RE: **Lot 9 Block 10 SAD 228**
Volcano Cliffs Subdivision
6400 Petirrojo NW
Grading and Drainage Plan
Engineers Stamp Date 12/7/14 (D10D003F9)
CO Certification Dated: Not Dated

Based upon the information provided in your submittal received 8/23/18, this plan cannot be approved for Certificate of Occupancy until the following comments are addressed.

DRAINAGE AND TRANSPORTATION INFORMATION SHEET (REV 6/2018)

ENGINEER'S SEAL 12/7/17 12/4/17 DAVID SOULE P.E. #14522	6400 PETIRROJO NW	DRAWN BY WCWJ DATE 12-01-17 21827-LAYOUT-12-01-17
	GRADING AND DRAINAGE PLAN Rio Grande Engineering 1806 CENTRAL AVENUE SE SUITE 201 ALBUQUERQUE, NM 87106 (505) 872-0899	SHEET # — JOB # 21827

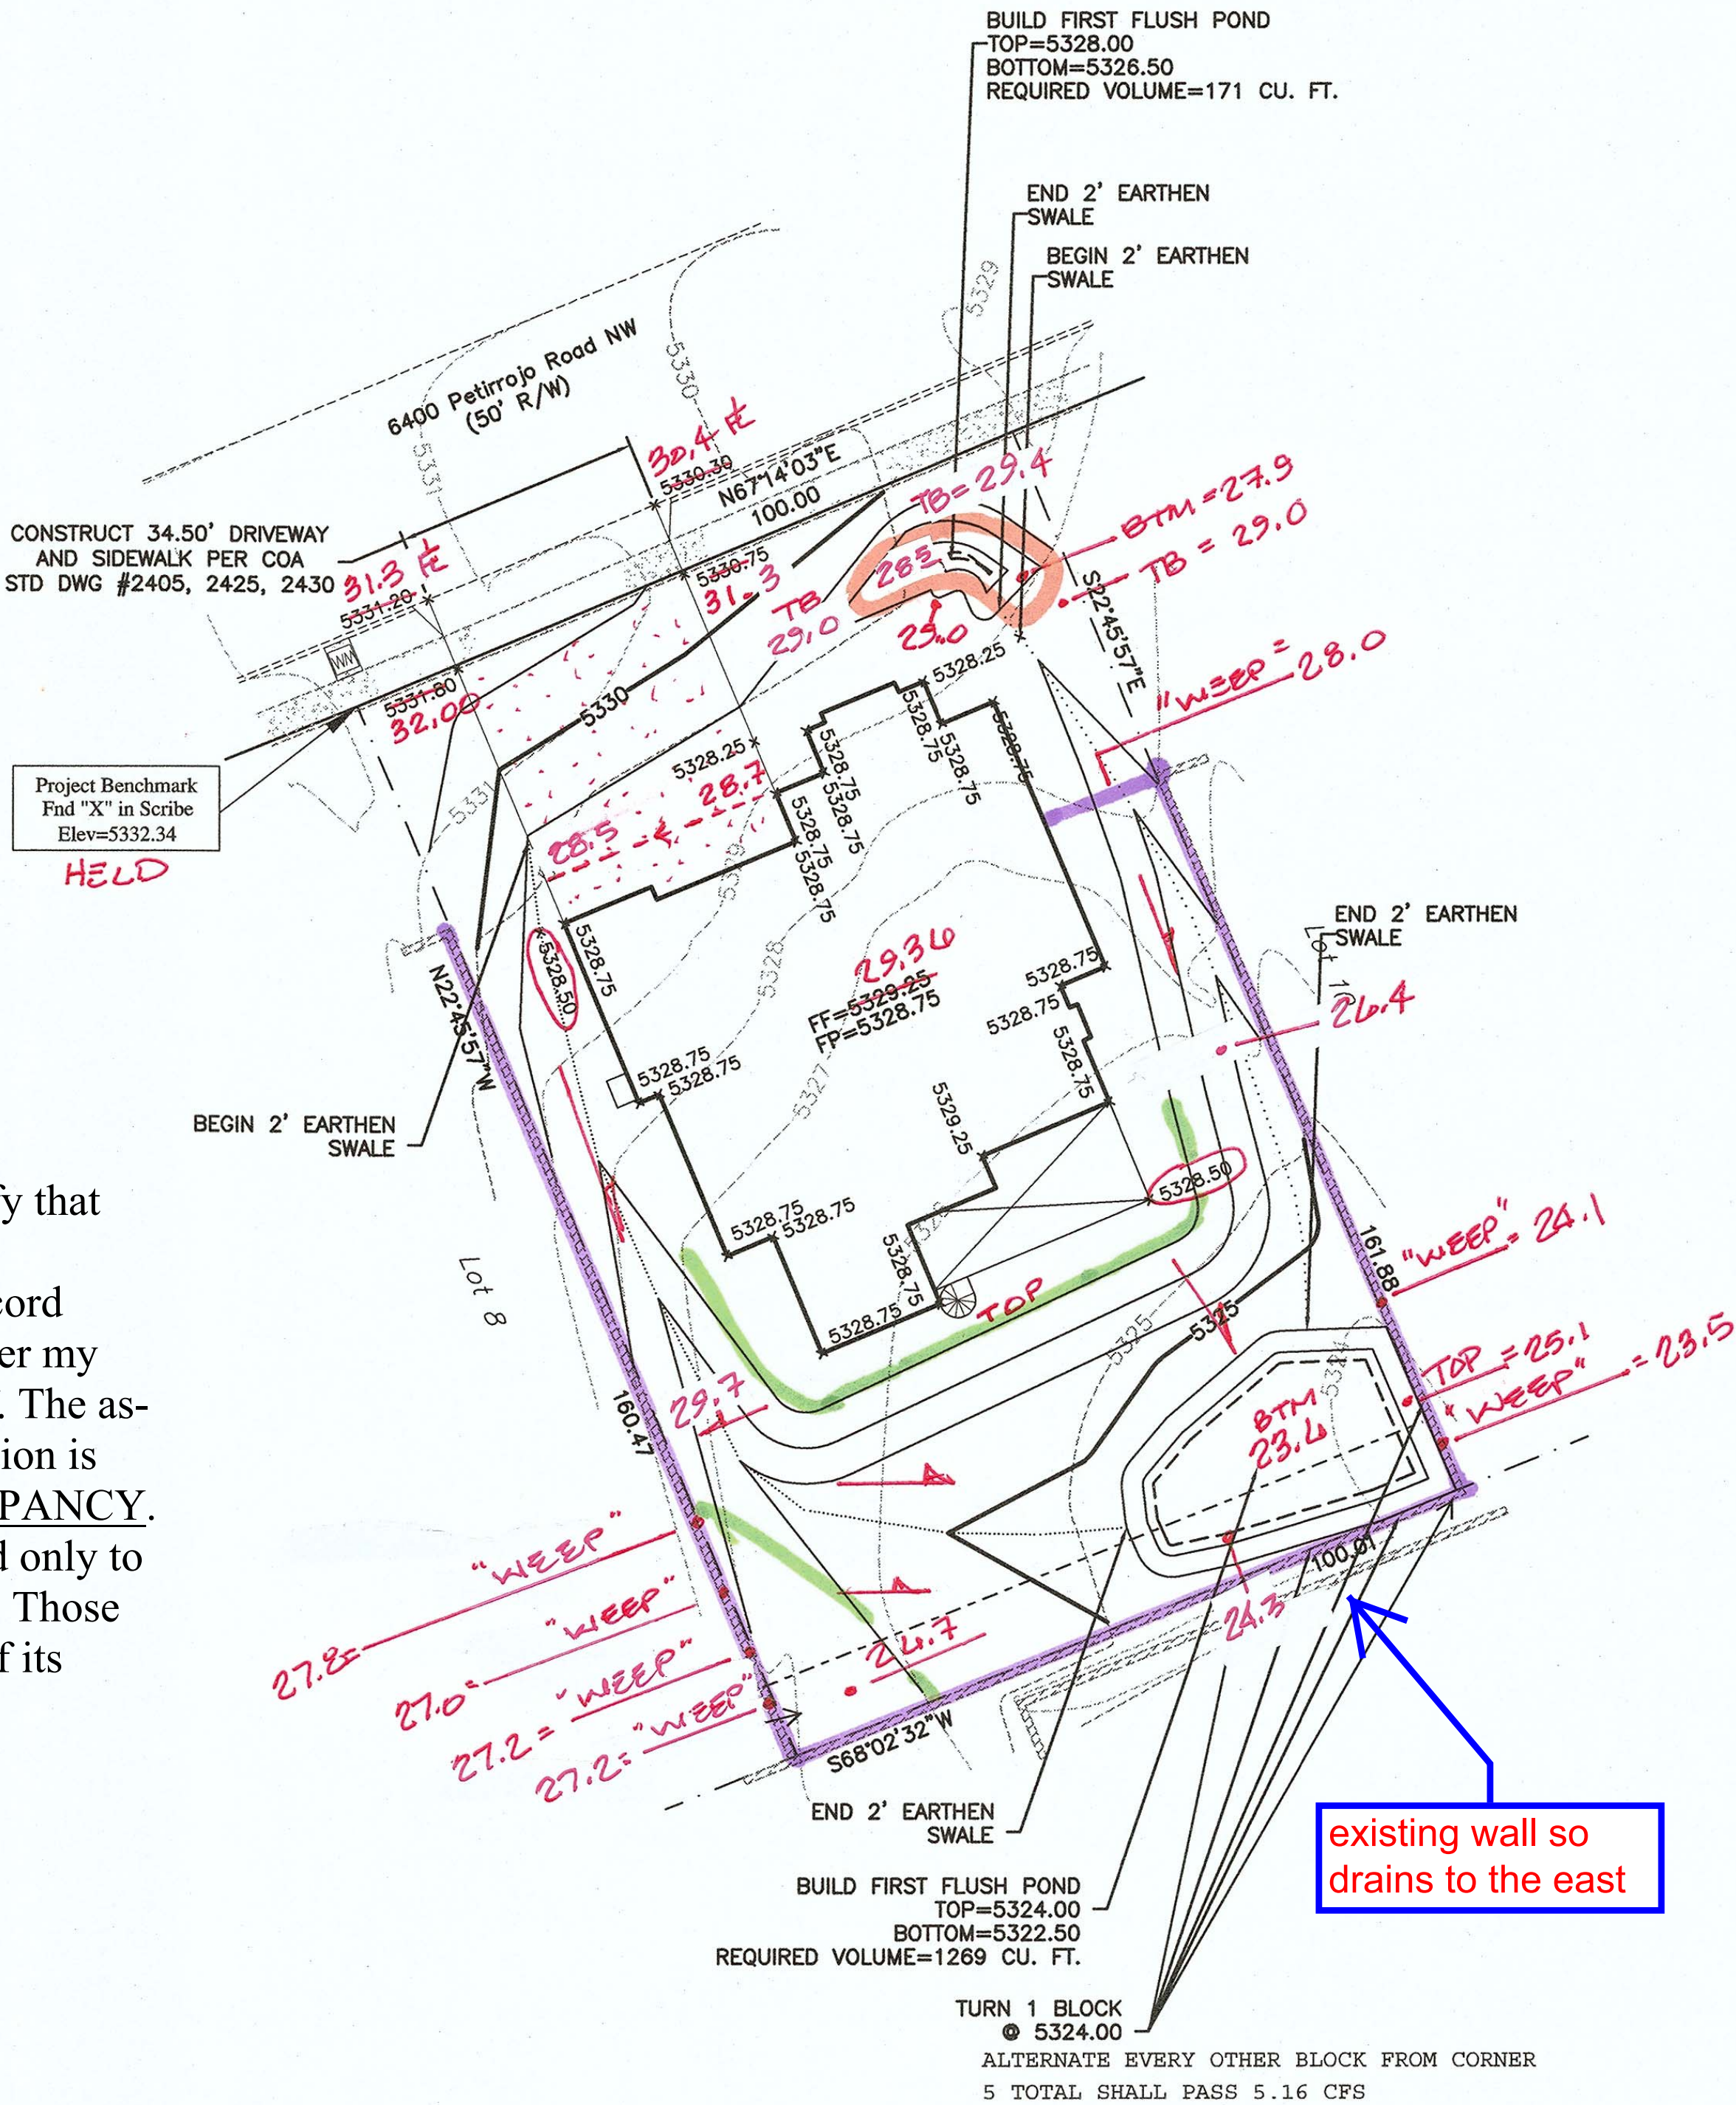
- Sign and date the certification for C.O.
- Provide the opening for the atrium and show where the inlets flows are directed.
- The inlets in the atrium were not installed properly. They are 2 – 3 inches above the finished gravel landscaping. Provide the spot elevations for the inlets inverts in and out.
